The influence of climate on hydro-electric development in Malaya and some design features of the Batang Padang scheme

P. G. D. SHALLOW, R. T. GERRARD & D. W. GREEN

DISCUSSION

Fig. 19. Bot settling tank : longitudinal section

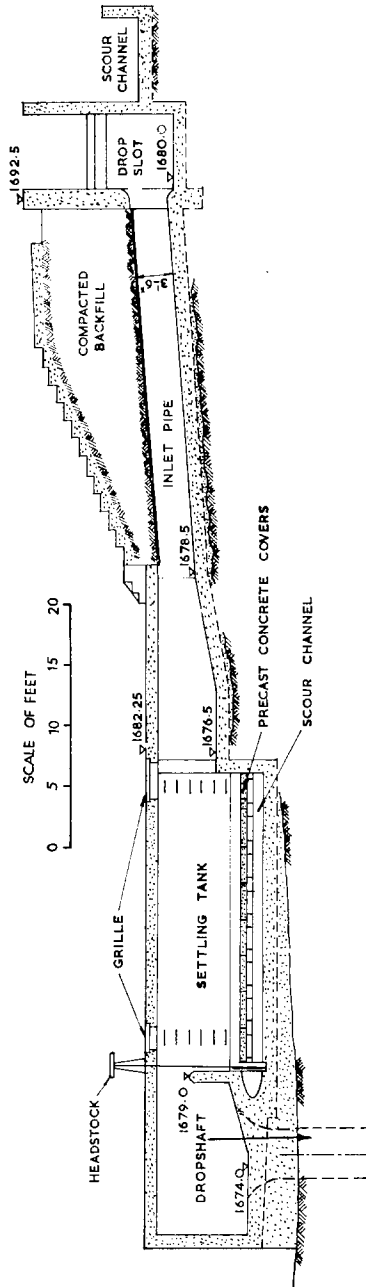
- (a) to what order of velocity is the stream reduced by the upstream pond?
- (b) what is the longitudinal section of the settling tanks?
- (c) does § 77 (b) refer to the total area of the gaps along both sides of the entire length of the precast concrete covers?
- (d) does § 76 include considerations in addition to that described in § 24? Any data on the relation between machine erosion and particle size would be interesting.

116. With regard to **Dr Wright's** questions about the side-stream intakes, no meaningful figure can be given for the velocity of the stream in the upstream pond as it depends upon the topography of the site, the inflow, and the length of the weir formed by the bed load excluder wall. A typical longitudinal section of a settling tank, requested by **Dr Wright**, appears in Fig. 19 which shows the tank on the Bot

sidestream intake. The total area of the gap referred to in § 77(b) is the total area available in the bottom of the tank through which sediment can pass. It is the total of the gaps on both sides of all the precast concrete covers.
